design west | architects

date:	5.17.24
project:	Nibley Middle School
by:	Michael Rigby
subject:	Addendum 03

CONTRACT ADDENDUM 03

M-112.C

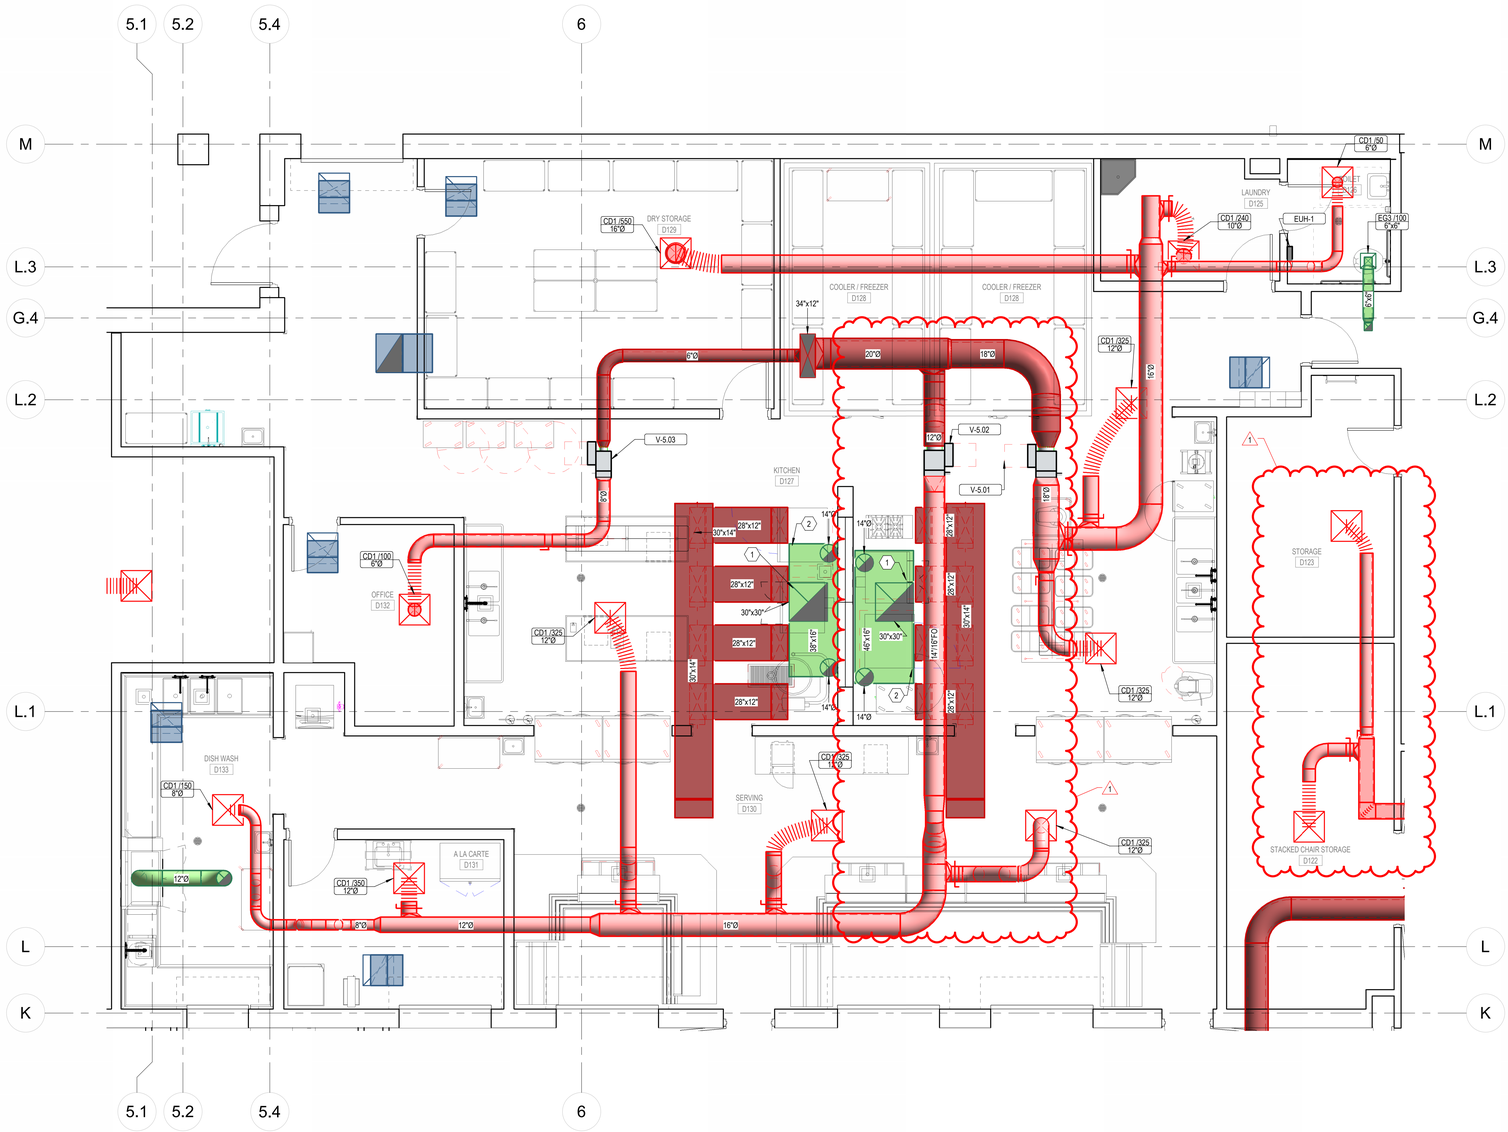
SHEET - M112.C
1. Add keyed note 2 as shown. See attached.

M-402

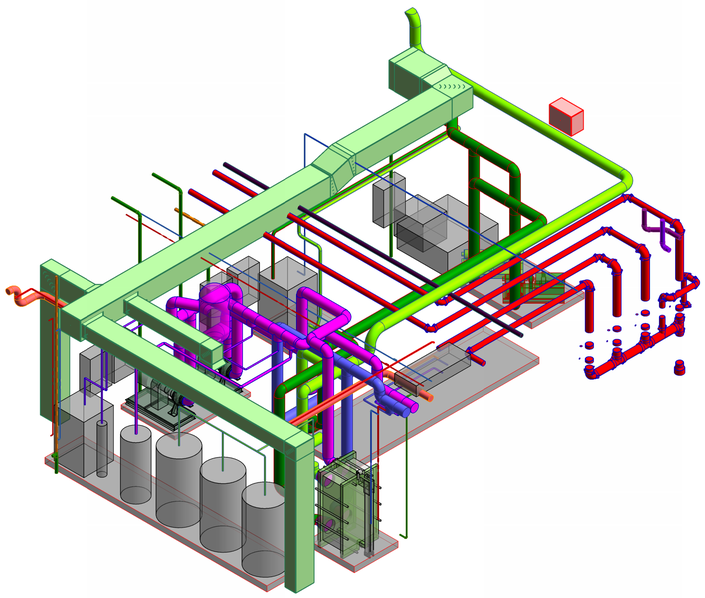
SHEET - M402
1. Add motorized dampers as shown. See attached.
2. Add keyed notes to pads as shown. See attached.

1 M-403 ENLARGED MECHANICAL HVAC PLAN - CHILLER ROOM
1/4" = 1'-0"

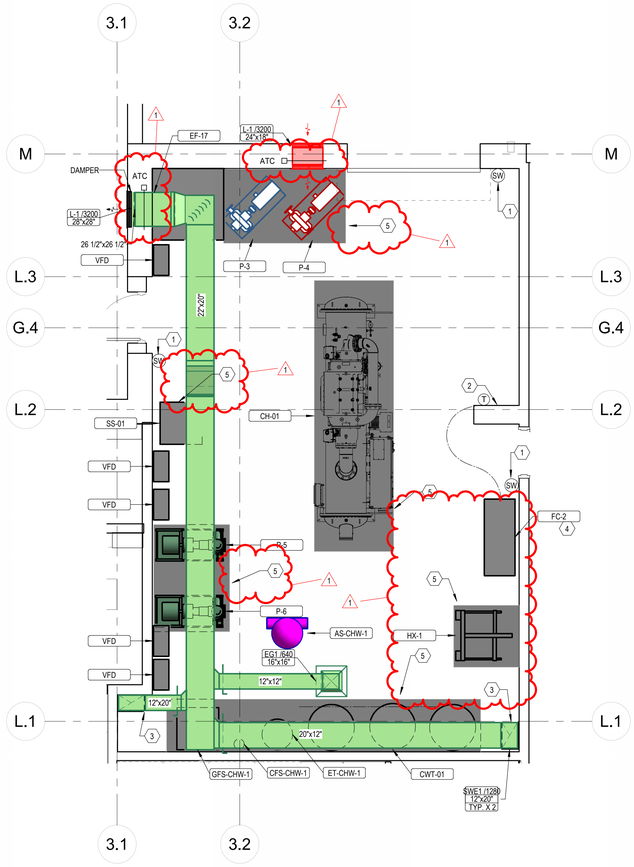
SHEET - M403
1. Add motorized dampers as shown. See attached.
2. Add keyed notes to pads as shown. See attached.

2 M-505 KITCHEN MAKE-UP AIR HANDLER DETAIL
NO SCALE

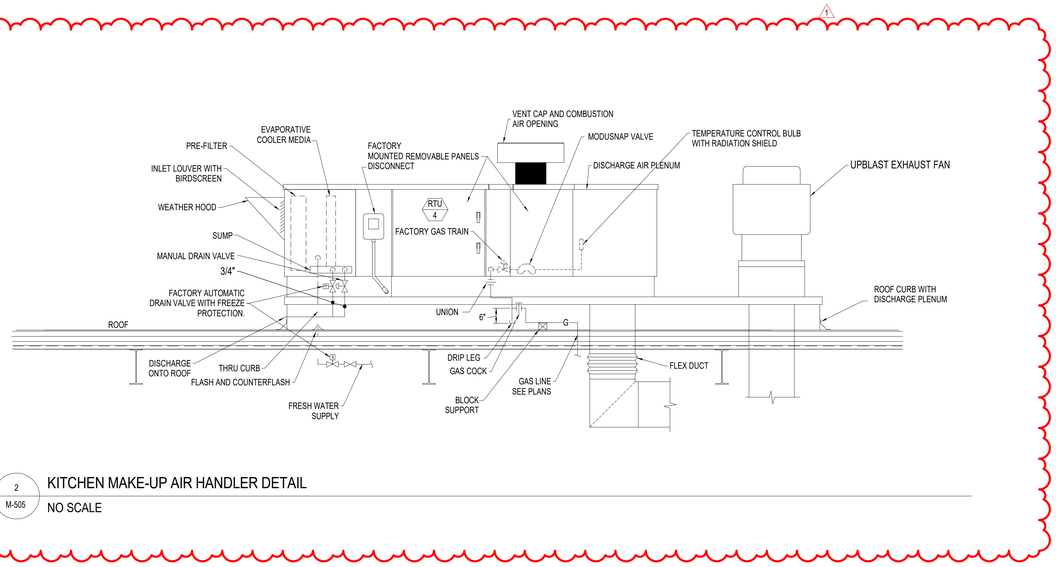
SHEET - M505
1. Add Make-Up Air Handler Detail as shown. See attached.

MP-111.C

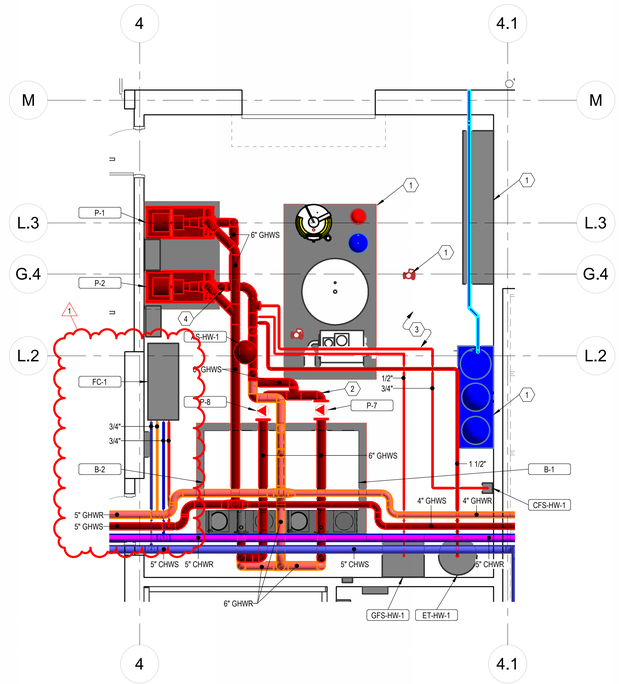
SHEET - MP111.C
1. Add hydronic piping as shown. See attached.

MP-402

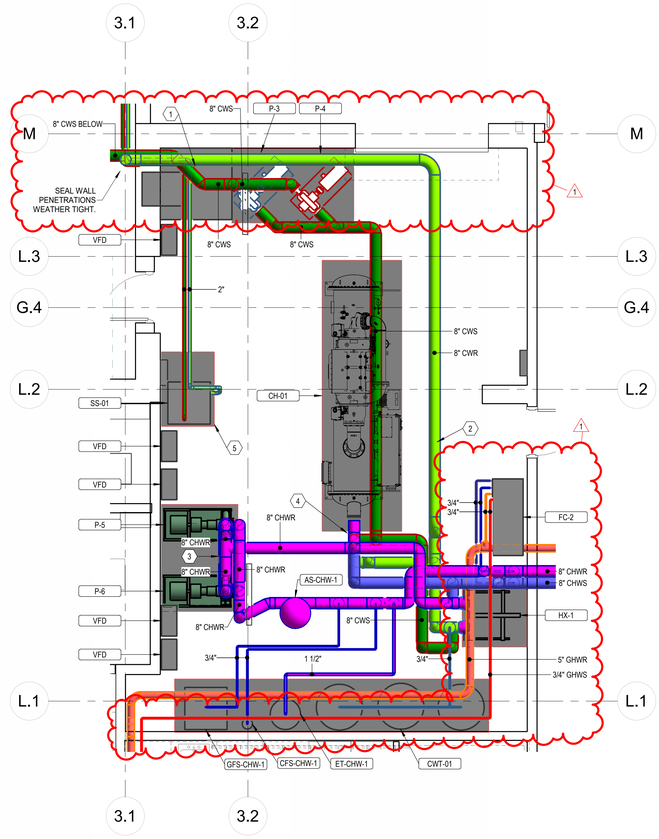
SHEET - MP402
1. Tag FC-1.

1 MP-401 ENLARGED MECHANICAL PIPING PLAN - COOLING TOWER
1/4" = 1'-0"

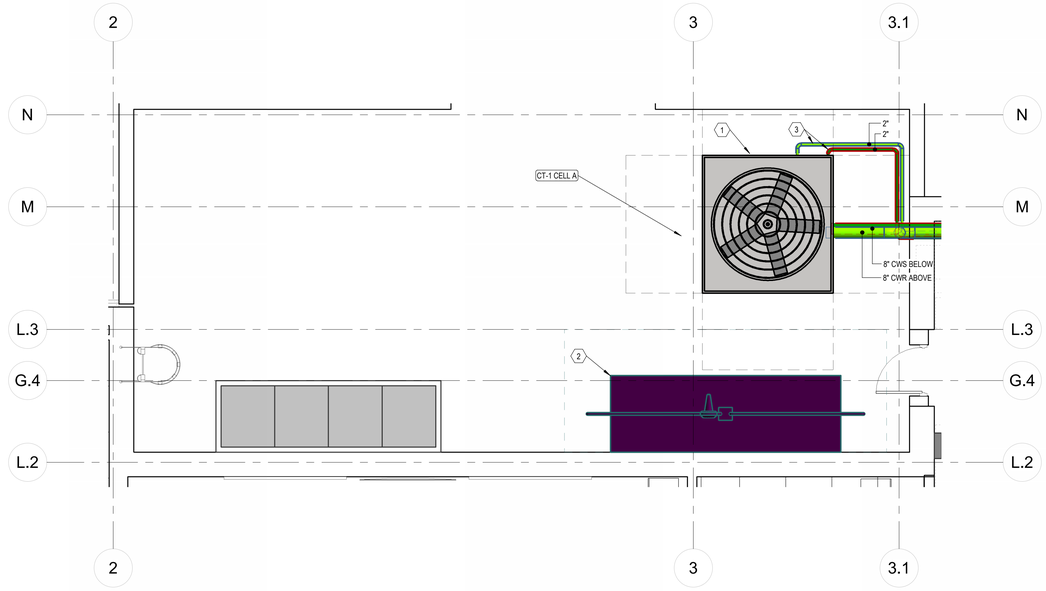
SHEET - MP401
1. Remove extra keyed notes as shown. See attached.

MECHANICAL PIPING SCHEMATICS
MP-702

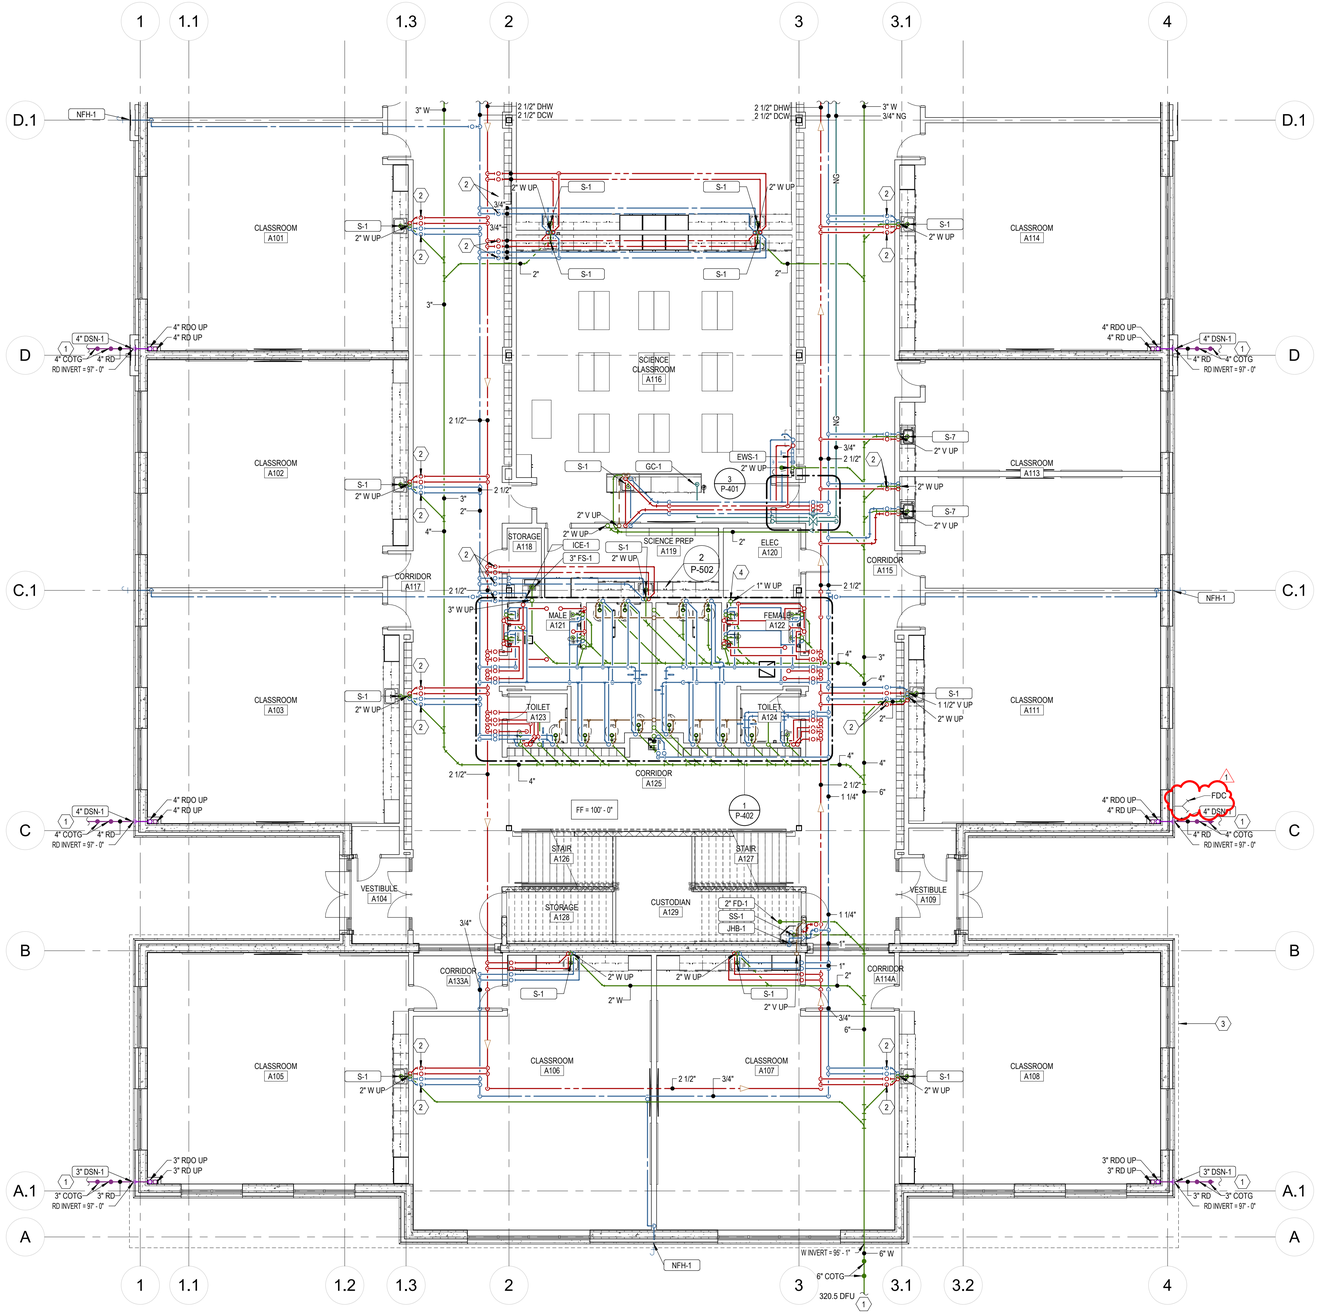
SHEET - MP702
1. Modify piping as shown. See attached.

P-111.A

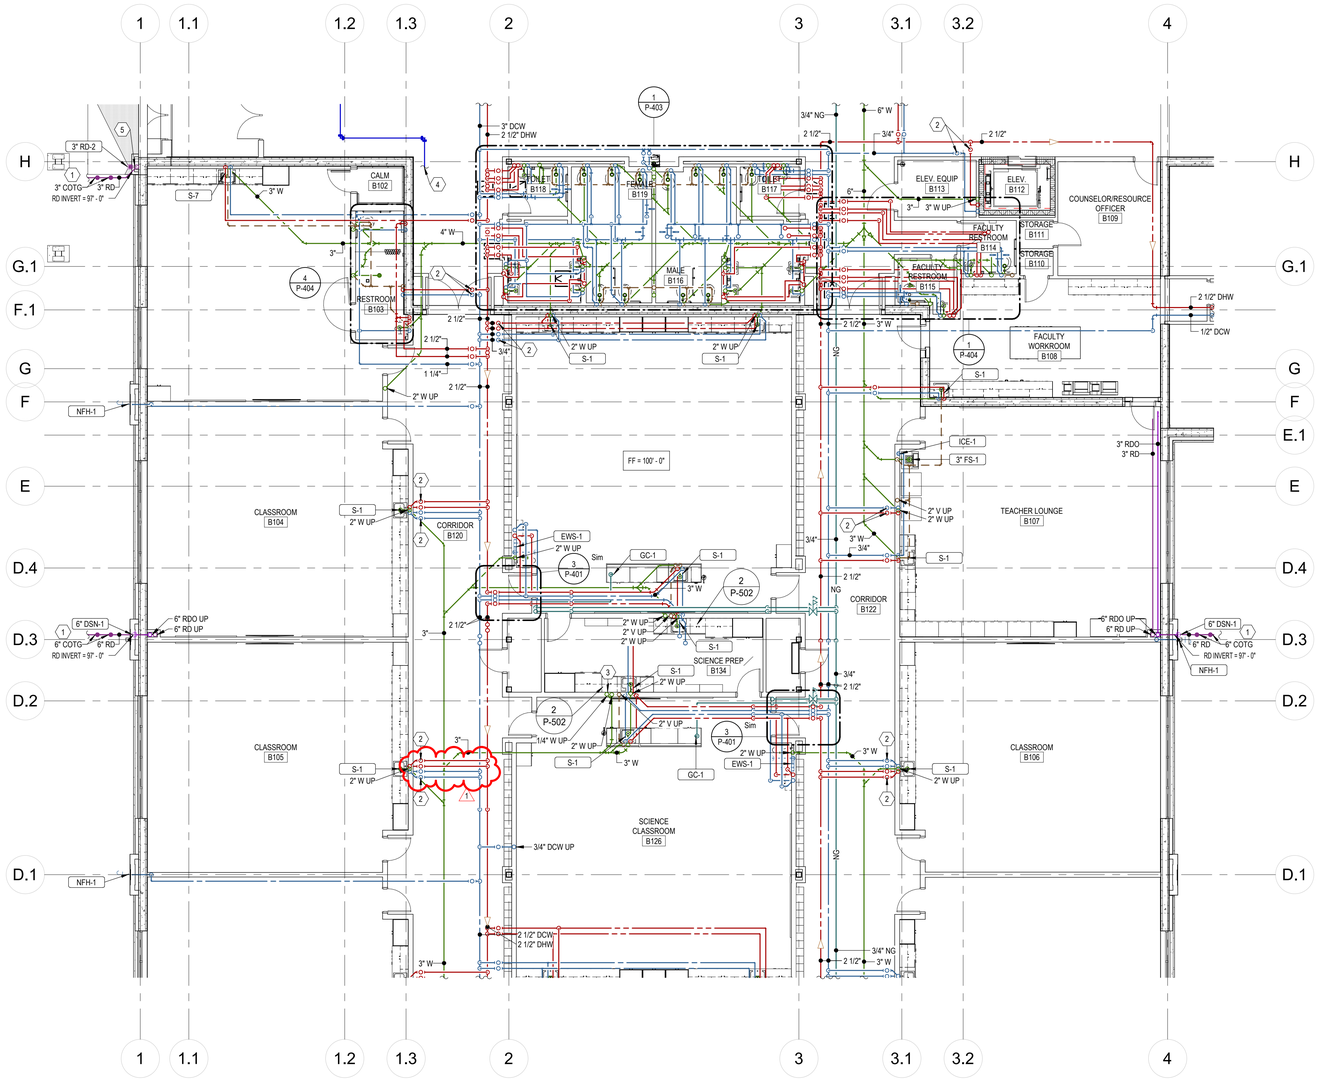
SHEET - P111.A
1. Locate the FDC as shown. See attached.

P-111.B

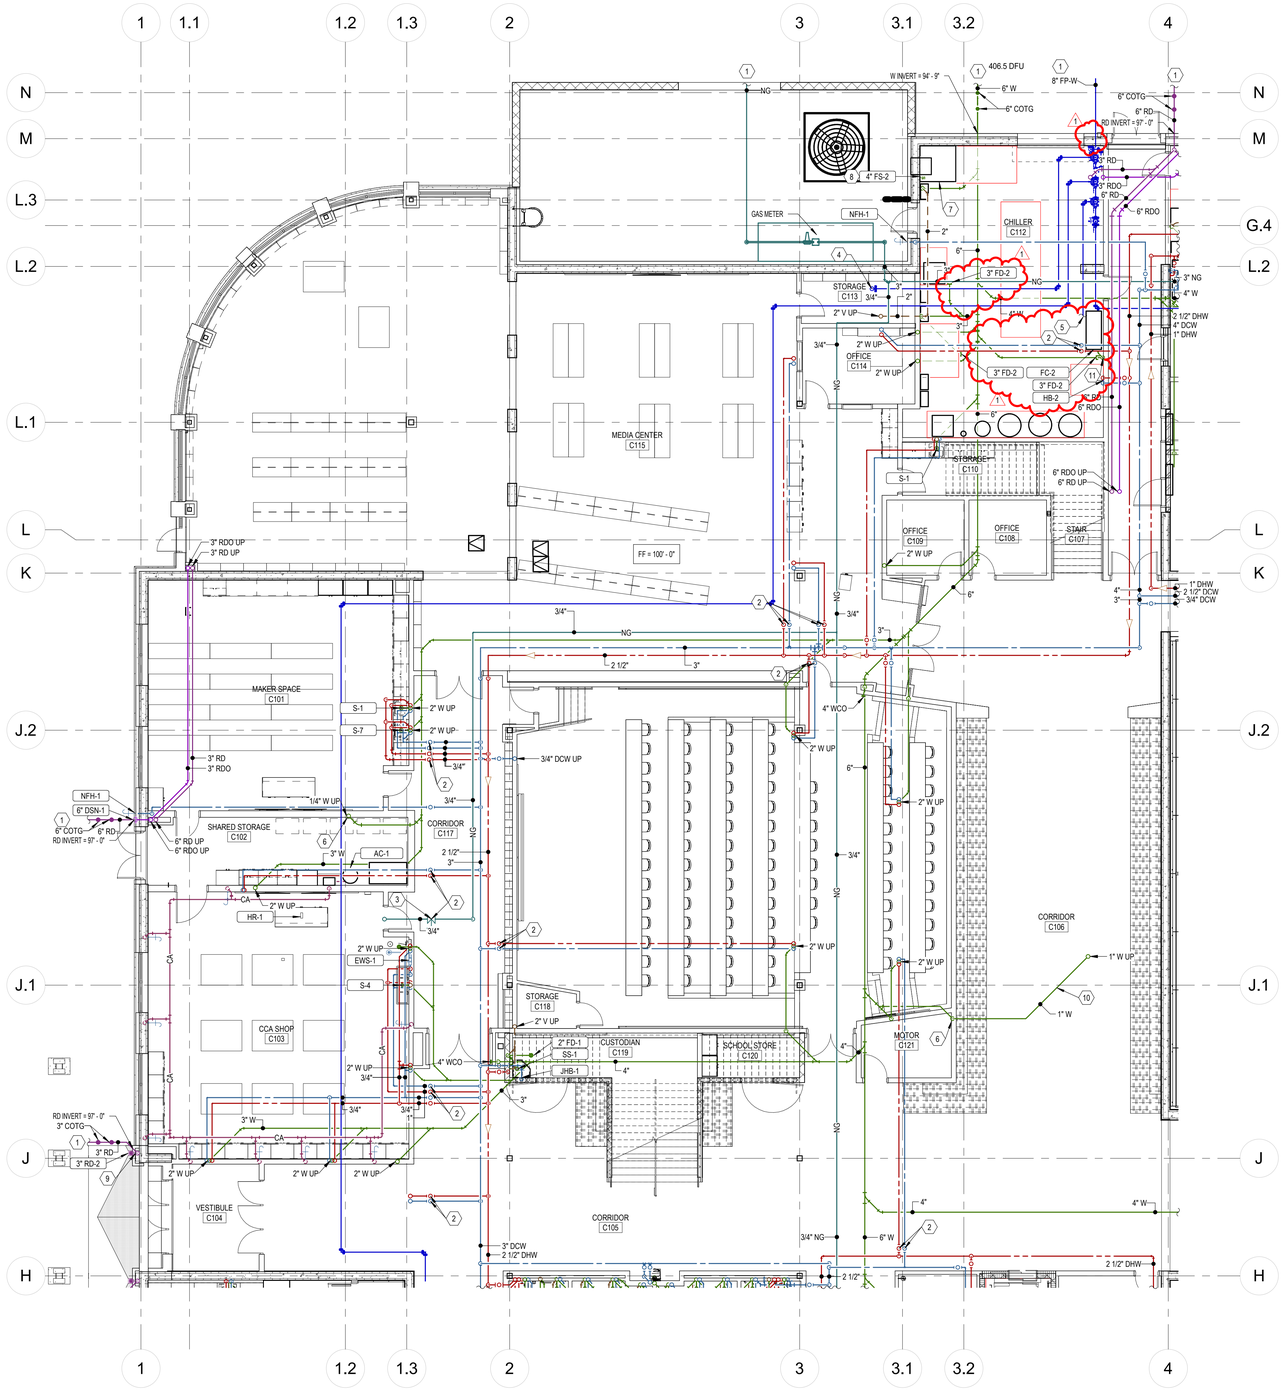
SHEET - P-111.B
1. Add domestic water piping as shown. See attached.

1 P-401 BOILER ROOM PLUMBING PLAN
1/4" = 1'-0"

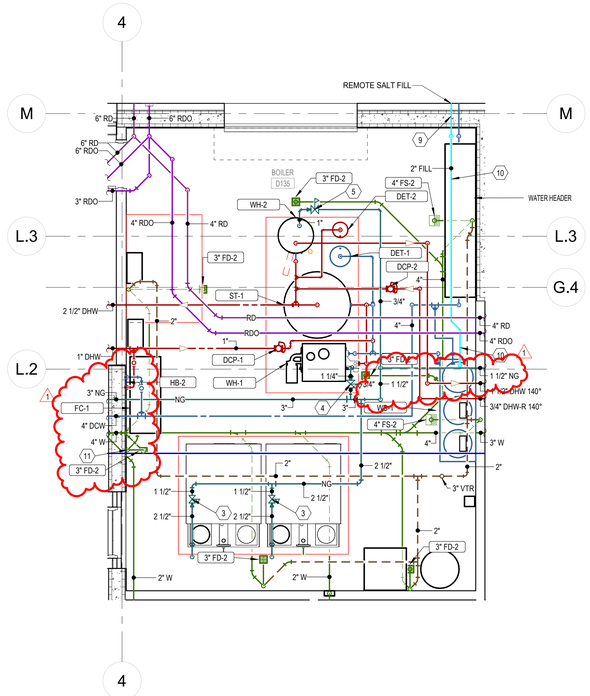
SHEET - P401
1. Modify gas piping as shown. See attached.
2. Add condensate drain to fan coil unit as shown. See attached.
